The following changes in the tender documents are effective immediately. This addendum will form part of the contract documents.

**END OF ADDENDUM No. 2**

**WILLIAM HEAD INSTITUTION ELECTRICAL HIGH VOLTAGE UPGRADE (PHASE 2 OF 2)**

Drawing title/Titre du dessin  
**ELECTRICAL DETAILS**

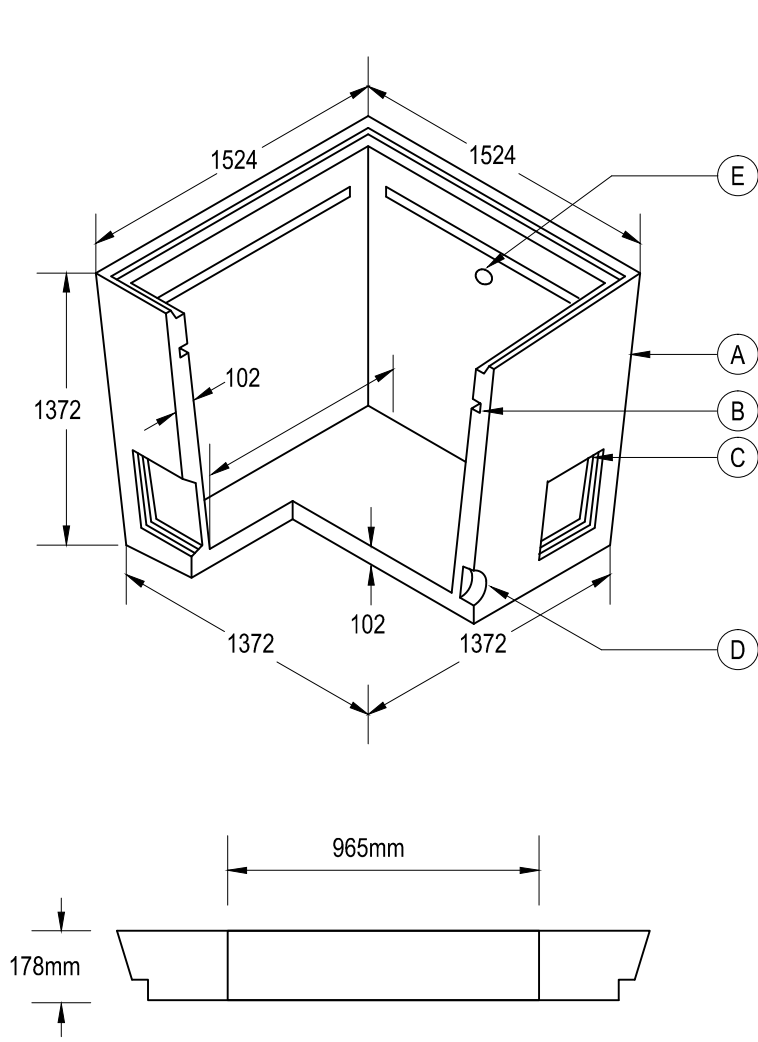
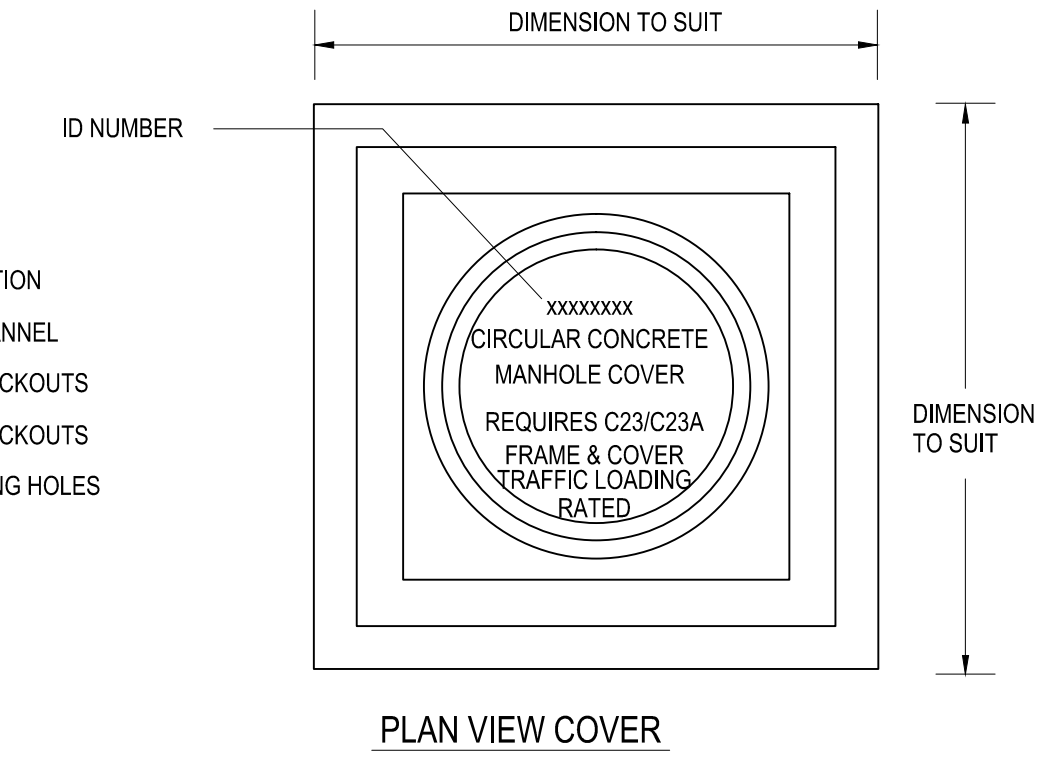
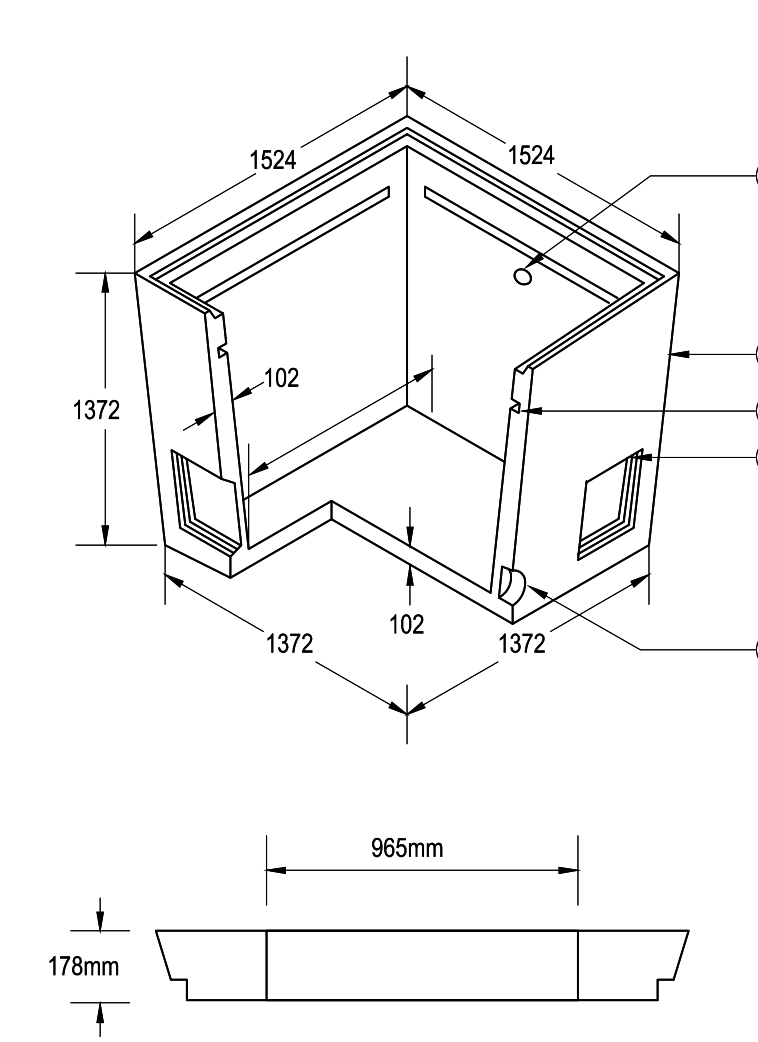
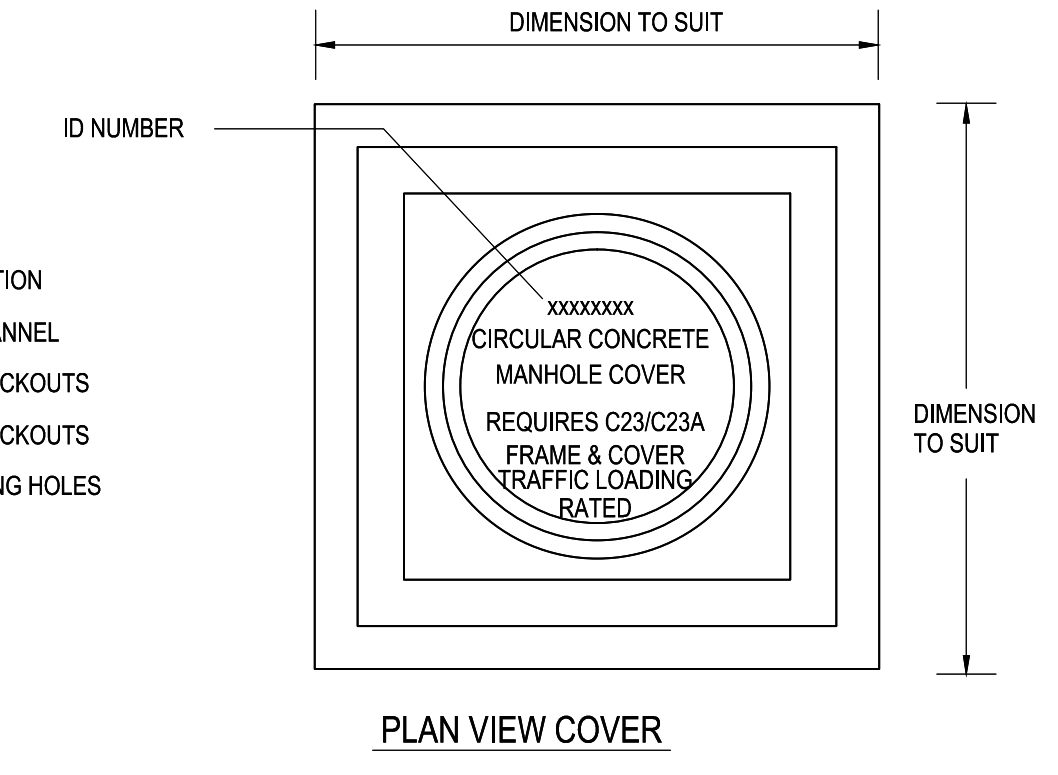
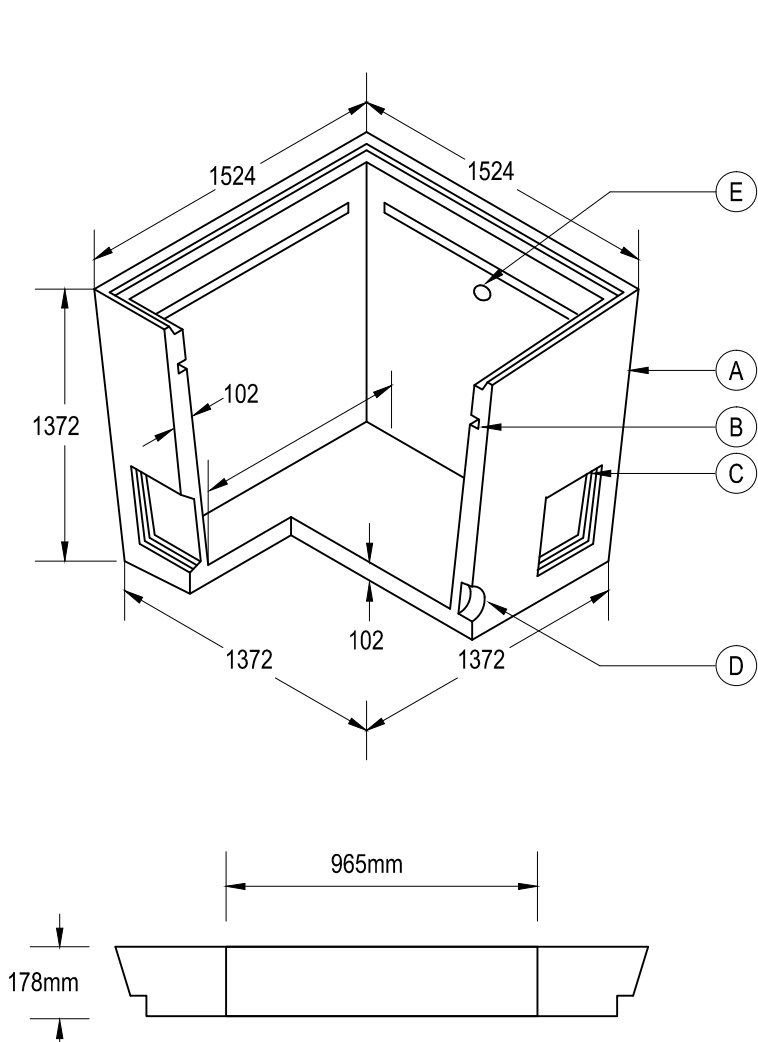
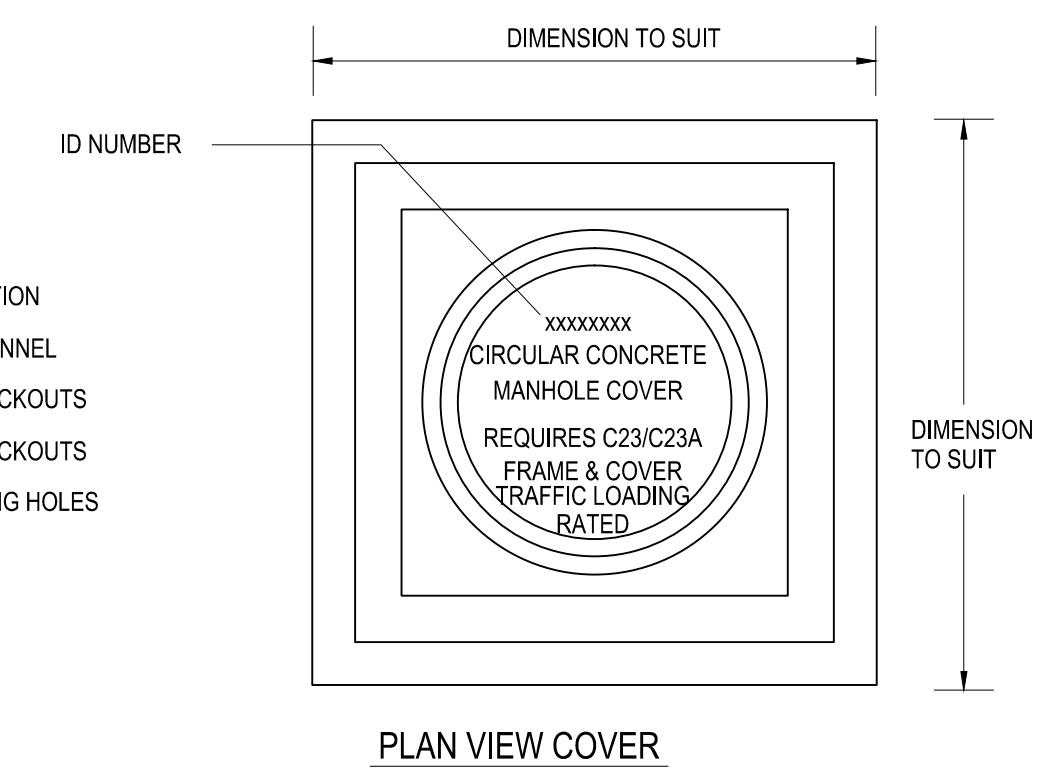
1. Clarify definition for traffic loading as noted.

GENERAL NOTES:  
1. ...  
2. PULLBOX CONSTRUCTION TO BE RATED FOR TRAFFIC LOADING AS PER THE AMERICAN ASSOCIATION FOR STATE AND HIGHWAY TRANSPORTATION OFFICIALS, STANDARD M306 SPECIFICATION FOR DRAINAGE, SEWER, UTILITY, AND RELATED CASTINGS.
